## Wick Commercial

2009-02-04

### Map of Wick Commercial (PLUS 2009-02-04)

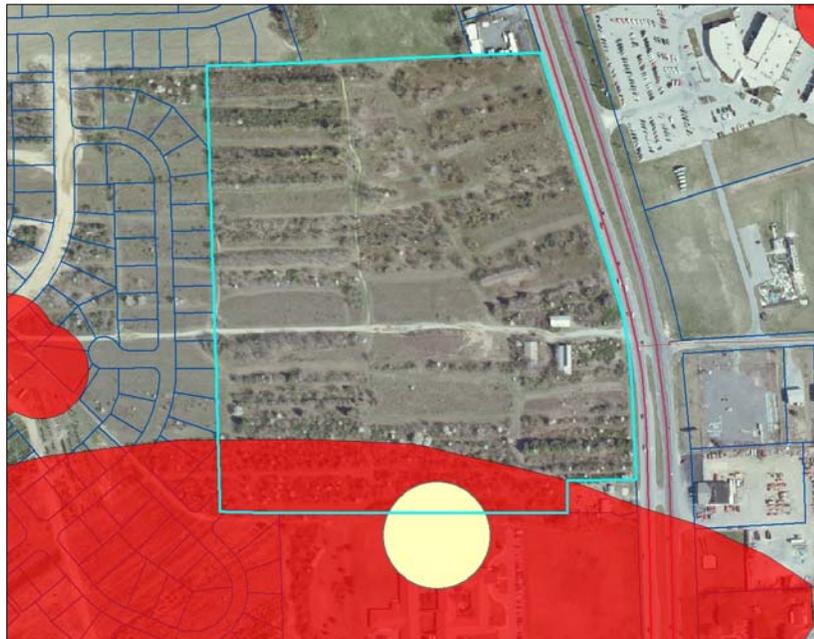
the Pinnacle Rehabilitation and Ridgewood Manor (see map). Wellhead protection areas are surface and subsurface areas surrounding a public water supply well where land use activities or impervious cover may adversely affect the quantity and quality of ground water moving toward such wells. The application does not indicate the amount of impervious cover within the proposed development.

DNREC Water Supply Section recommends that the portion of the new development within the wellhead protection area not exceed 20% impervious cover (DNREC, 2005). Allowance for augmenting ground-water recharge need be implemented if the impervious cover exceeds 20% but is less than 50% of that portion of the parcel within the wellhead protection area from the edge of the 150-foot radius to the outer edge of delineated wellhead protection area. However, the development should not exceed 50%. A water balance calculation is necessary to determine the quantity of clean water to be recharged via a recharge basin (Kaufmann, 2005). The purpose of an impervious cover threshold is to minimize loss of recharge (and associated increases in stormwater) and protect the quality and quantity of ground water and surface water supplies.

- Because a portion of the parcel falls within the 150-foot radius of two public wells (see map), the impervious cover in this portion of the wellhead protection area should be limited to the buildings, treatment facilities, and access ways associated with the maintenance of the well.

- Reduce impervious cover to 20% or less. The development cannot exceed 50%. If it falls within the 20 to 50% range there must be an environmental assessment report including a climate budget, documenting post-development is equal to or greater than predevelopment recharge when calculated on an annual basis.

- Relocate any open space areas to the part of the parcel within the wellhead protection area.
- Direct run off from the impervious surface away from the wellhead protection area.

- Augment ground-water recharge with clean rooftop run-off systems
- A water balance calculation will be necessary to determine the quantity of clean water to be recharged via a recharge basin (DNREC, 2005; Supplement 1).
